Staff Summary Report

Development Review Commission Date: 11/27/07

SUBJECT: Hold a public hearing for a Zoning Map Amendment, Planned Area Development Overlay and Development Plan Review for **CAMPUS SUITES ON THE RAIL** located at 1900 E Apache Boulevard.

DOCUMENT NAME: DRCr_CampusSuites_112707

Garage Elevations
 1/16" = 1'-0"

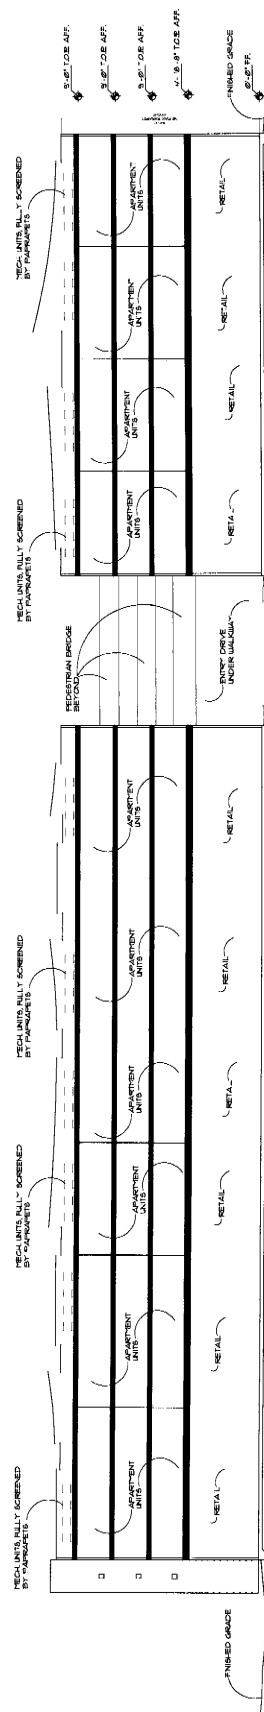
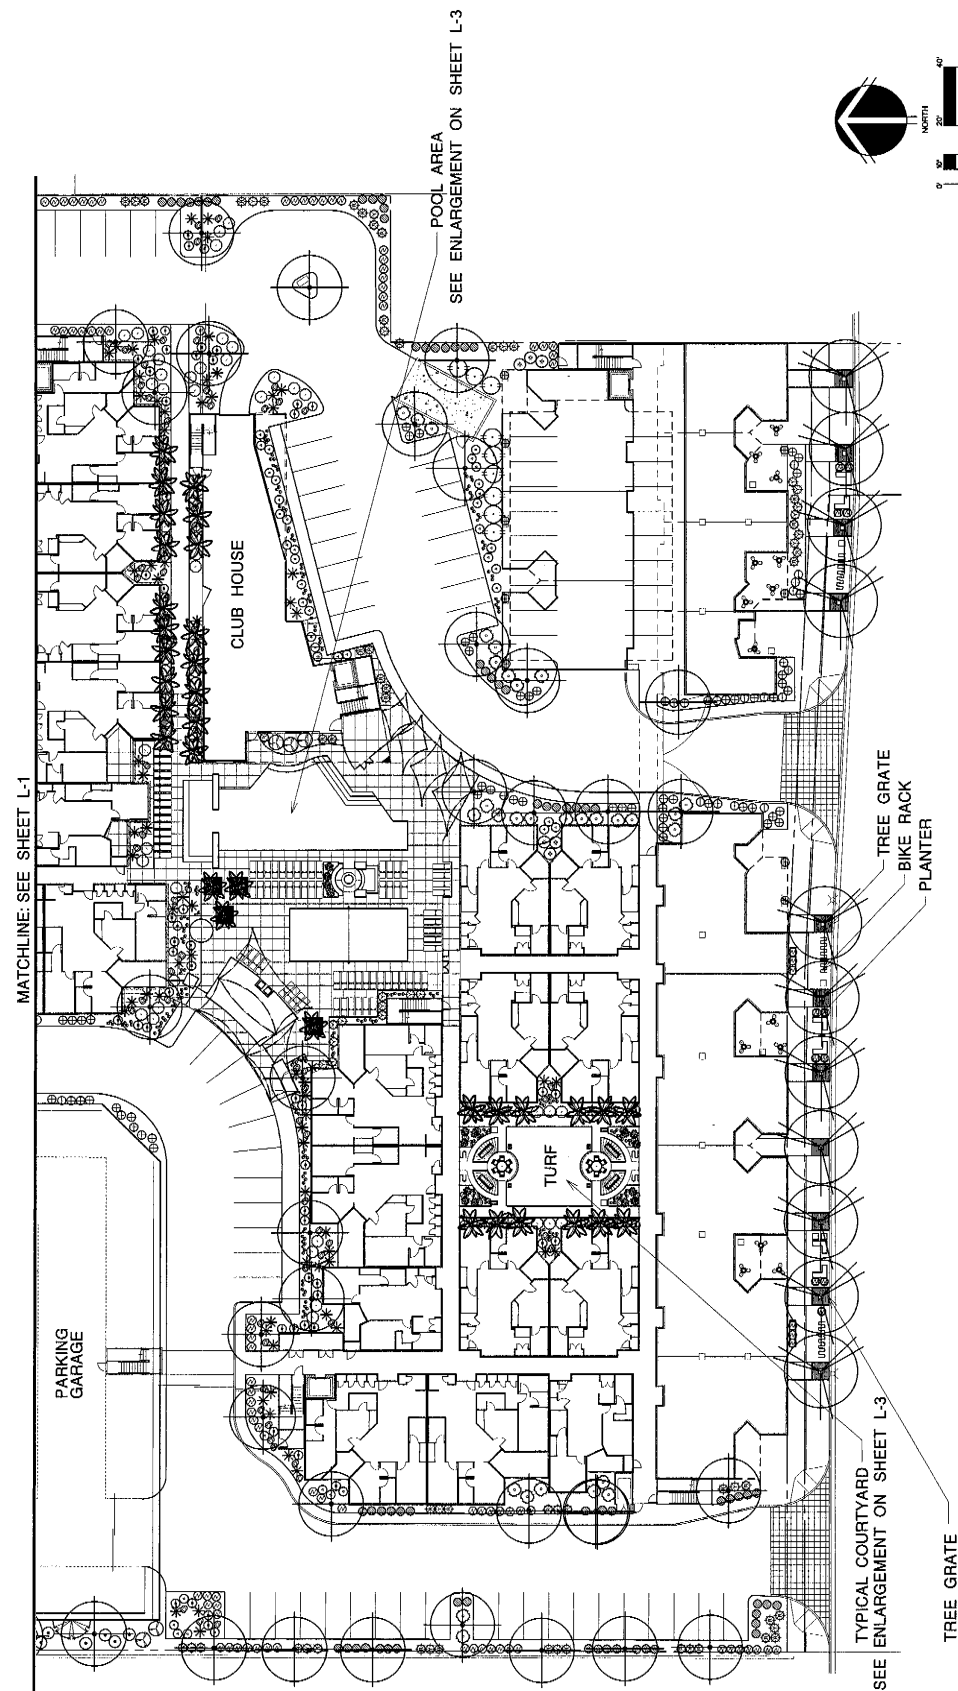
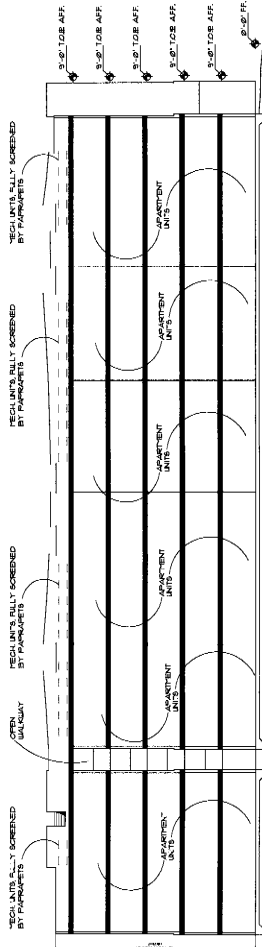
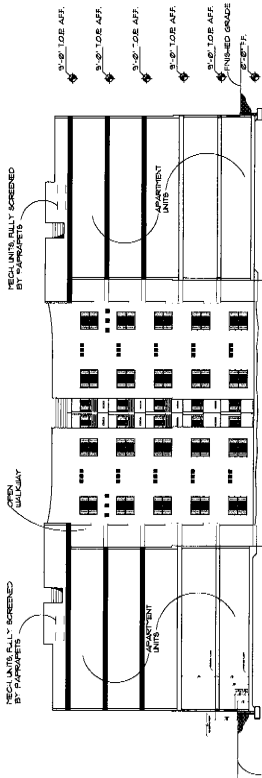
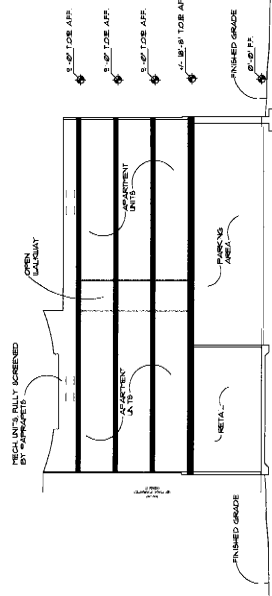
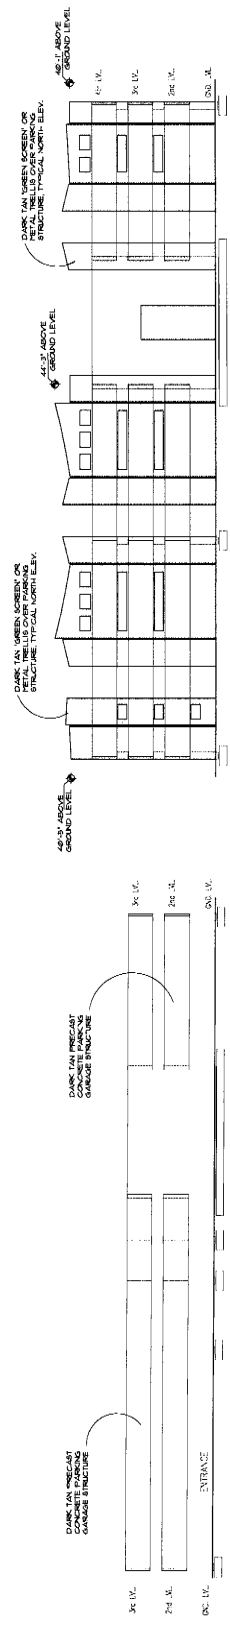
27. Add 5 gallon Ficus pumila: Creeping Fig or other staff approved vine to the east and south face of the parking garage.
